Field Service Bulletin No. 45 for

ADC Compact

New material for scan rollers introduced (CM+9.5145.2650.1)

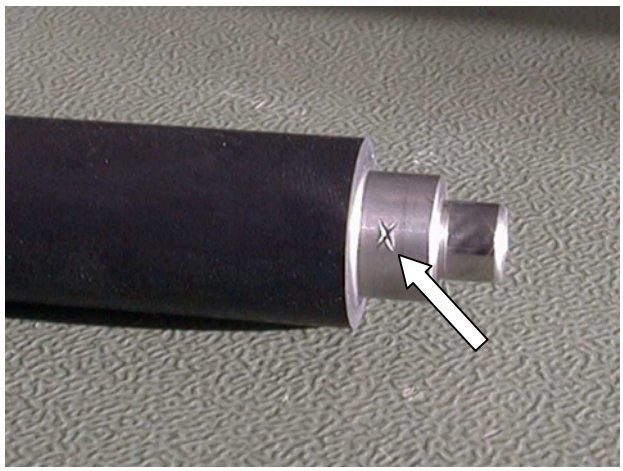
Exchange the scan rollers. A new material for the scan rollers has been introduced.
These altered scan rollers are marked with an "X", see figure beside.

CM+9.5145.2650.1	Scan rollers with new material
